STAFF REPORT COMMUNITY DEVELOPMENT DEPARTMENT

SUBJECT: H-2020-0017 Quartet Northeast
H-2020-0018 Quartet Southeast

LOCATION: 4020 & 4340 N. Black Cat Rd. [Parcels: #S0434233652; S0434244210; S0434233920; S0434325860 (partial), in the west ¼ of Section 34, T.4N., R.1W.]

D. Landscape Plan (date: 1/30/2020)

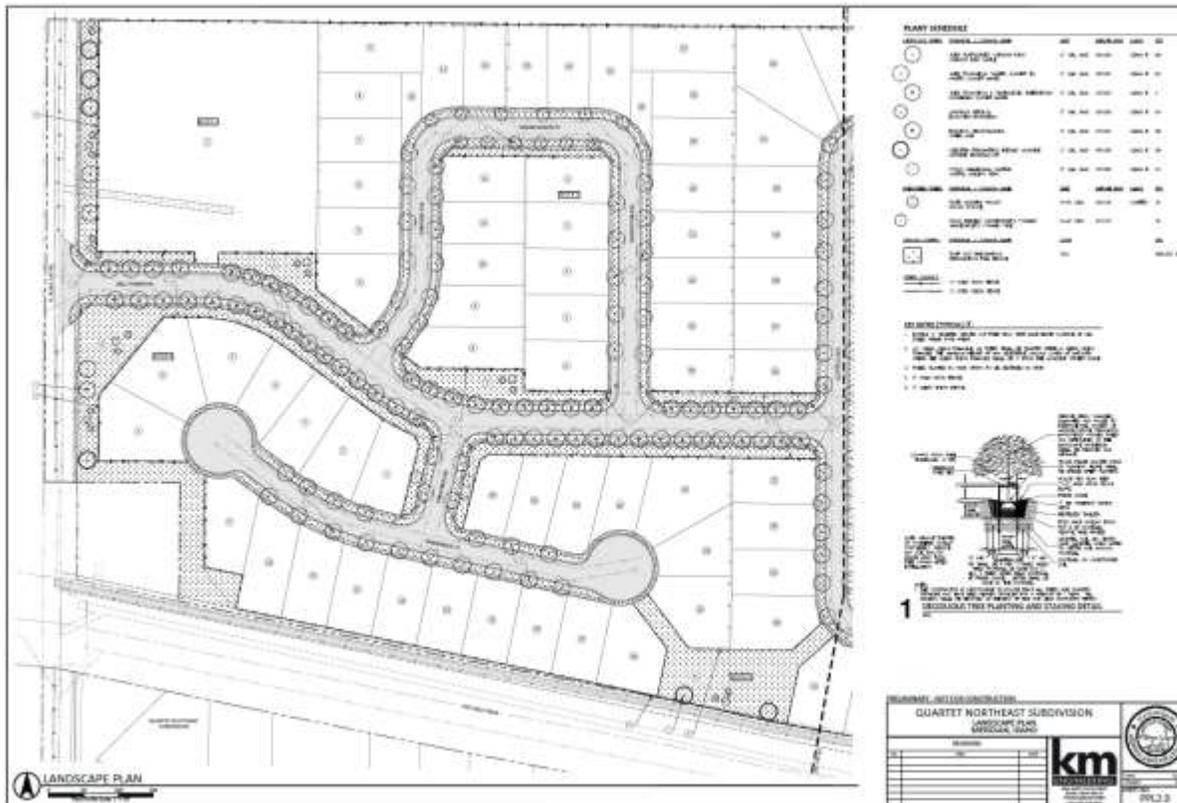
The Creason Lateral runs across the eastern portion of the north boundary of Quartet Northeast subdivision in Lot 34, Block 4 within a 40-foot wide easement and is proposed to be left open. **Because this area is included in the qualified open space calculations for the site, it should be landscaped per the standards listed in UDC 11-3G-3E – no landscaping is depicted on the landscape plan for that area.**

Six-foot tall solid wood fencing is proposed along the perimeter boundary of the site and along side yards adjacent to the street; and 5-foot tall clear vision fence is proposed adjacent to most internal common open space areas. **To provide more visibility of the common area on Lot 34, Block 4 where the Creason Lateral is located, Staff recommends fencing adjacent to the common lot complies with the standards listed in UDC 11-3A-7A.7.**

The Creason Lateral is required to be fenced with an open vision fence at least 6' in height and having an 11-gauge, 2" mesh or other construction, equivalent in ability to deter access to the waterway. If the Applicant can demonstrate to the satisfaction of the Director that the waterway serves as or will be improved as a part of the development to be a water amenity as defined in UDC 11-1A-1, it is not required to be fenced per UDC 11-3A-6C. If it's improved as a water amenity, construction drawings and relevant calculations prepared by a qualified licensed professional registered in the State of Idaho shall be submitted to both the Director and the authorized representative of the water facility for approval.

3. The landscape plan submitted with the final plat application shall be revised as follows:
 - a. Add pedestrian pathways from the internal sidewalks along Miramente Ct. and Miramente Dr. through adjacent common areas to the multi-use pathway along the Five Mile Creek; provide breaks in the fence where necessary to provide a connection. Also provide micro-path connections through Lot 10, Block 4 and Lot 7, Block 3 for pedestrian interconnectivity within the subdivision.

- f. The location of site amenities shall be depicted on the plan; a detail shall be submitted for the children's play equipment.
 - g. Depict landscaping in Lot 34, Block 4 in accord with the standards listed in UDC 11-3G-3E.

- h. Depict fencing on Lot 34, Block 4 where the Creason Lateral is located per the standards listed in UDC 11-3A-7A.7 to provide more visibility of the common area.
